Replacement Requirements for Components of the LED Matrix Main Headlights: No Mixed Installation of Component Parts is Permitted (25/24)

Model Line: **Taycan (Y1A / Y1B / Y1C)**

Concerns: **Headlight and LED light source control unit (matrix module)**

Installation position of the headlight control unit and LED light source

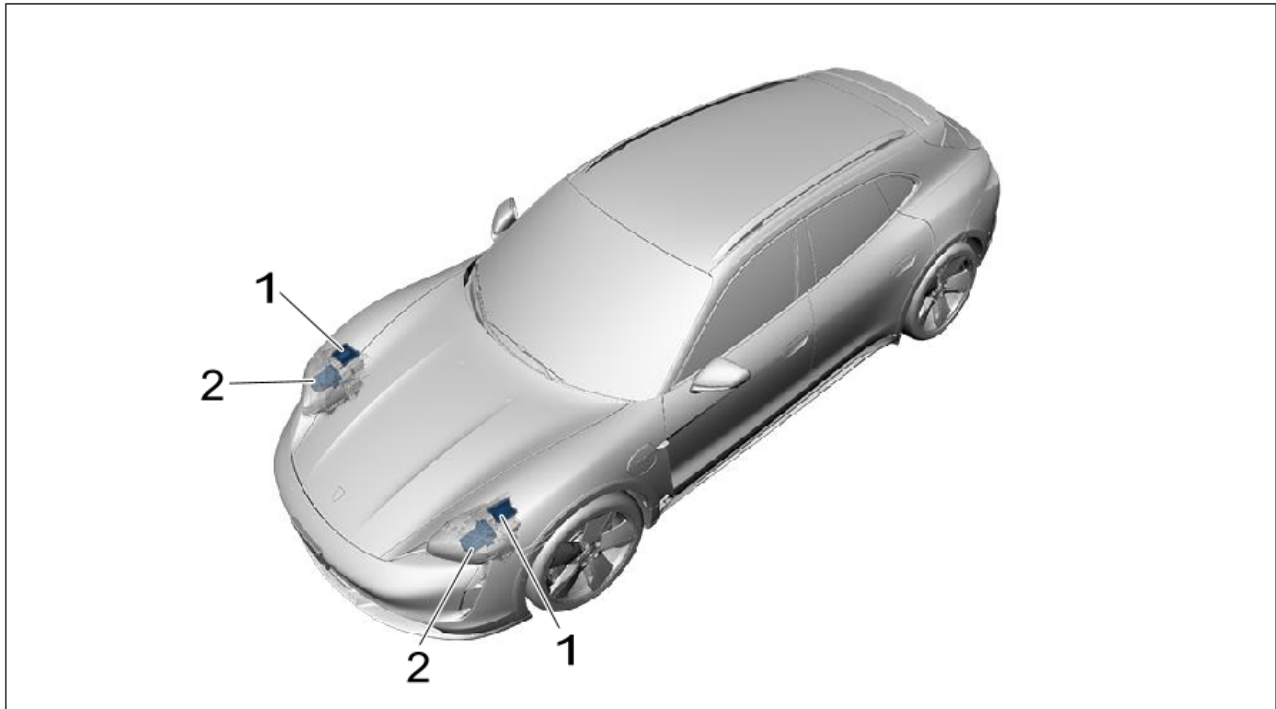
Cause: **Different component levels are available for the headlight control unit and the LED light source (matrix module) in the event of a replacement requirement. The previous component levels are not compatible with the new component statuses.**

Action: Determine the components required for a replacement using the table in the section ⇒ *Technical Information 'overview for permissible combinations and options'*, and depending on the determined need for replacement, replace the defective **components** or **replace both previous components (headlight control unit and LED light sources) with the new component level.**

If the affected components on an LED matrix main headlight are replaced by the new component level, the second LED matrix main headlight can continue to be operated with the previous control units (mixed installation of complete LED matrix main headlights is possible).
